STATE OF IDAHO
DEPARTMENT OF WATER RESOURCES
APPLICATION FOR PERMIT
To appropriate the public waters of the State of Idaho

Ident. No. 63-35138

RE: Application for Permit No. 63-35138

Re: Permit Application Incomplete & Basin 63 Ground Water Restricted Area Information Request

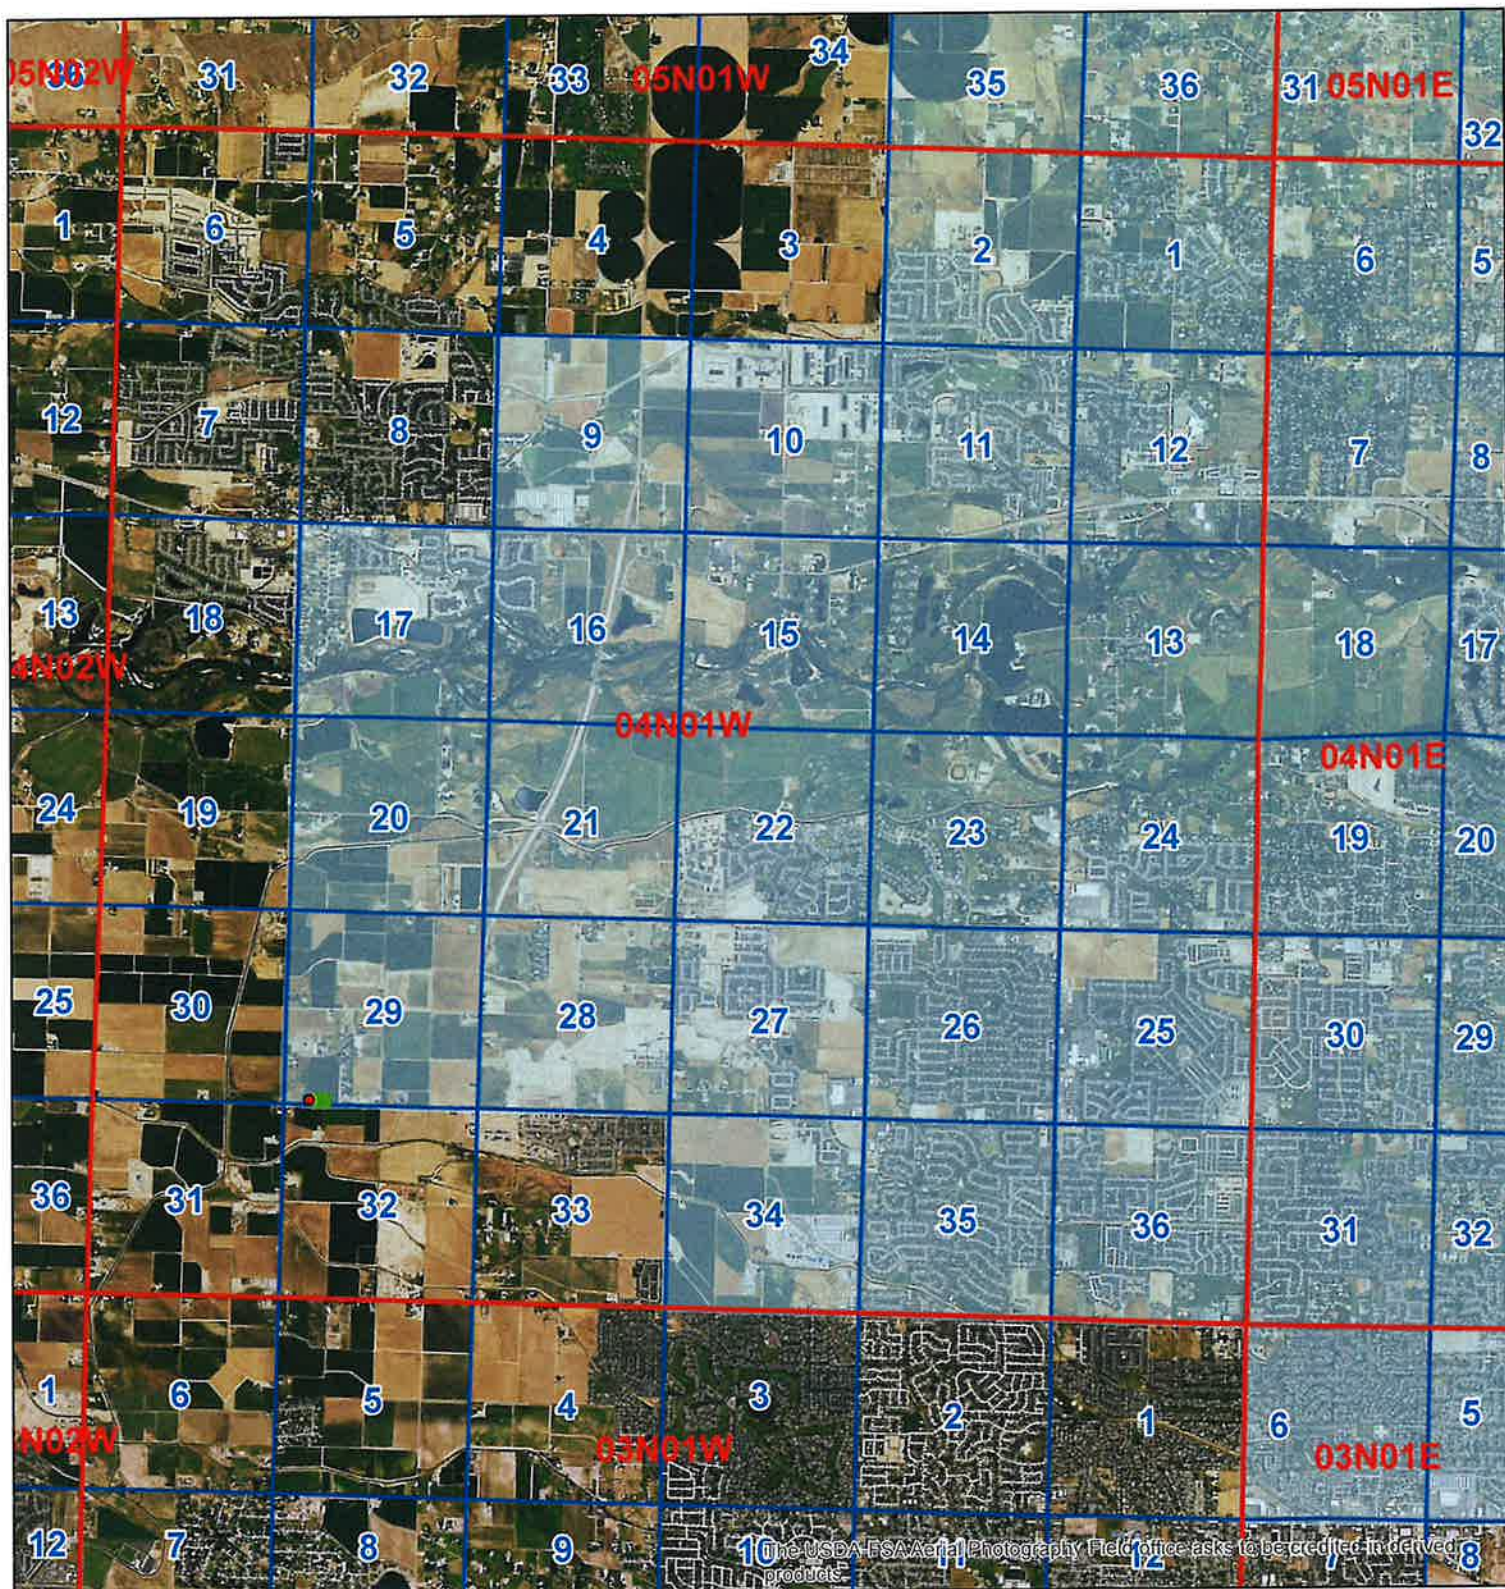
63-35128 proposes to irrigate using an existing well with a depth of 199 ft. and does not include plans to mitigate. Due to the size of the proposed usage and the location of the well within the Basin 63 GWRA, the Department will conditionally waive the requirements for this right.

Joint Fairview's application proposes a diversion rate of 0.03 cfs. This is a relatively small diversion rate that is not anticipated to significantly impact local ground water levels.

Joint Fairview propose using water from an existing well (D029335). The well is located approximately 50 feet north of the southernmost boundary and approximately 300 yards east of the westernmost boundary of the restricted area (see attached map). Furthermore, the well is located at a hydrologic downgradient relative to the rest of the groundwater within the restricted area, meaning no surrounding groundwater users within the restricted area will be impacted by take from well D029335.

Upon approval, 63-35128 will be conditioned as supplemental to the use of shares from Nampa & Meridian Irrigation District. The approval will also contain a condition explaining that, should the well ever need upgrade or replacement, the applicant will be required to upgrade or replace the well in compliance with the Basin 63 GWRA restrictions.
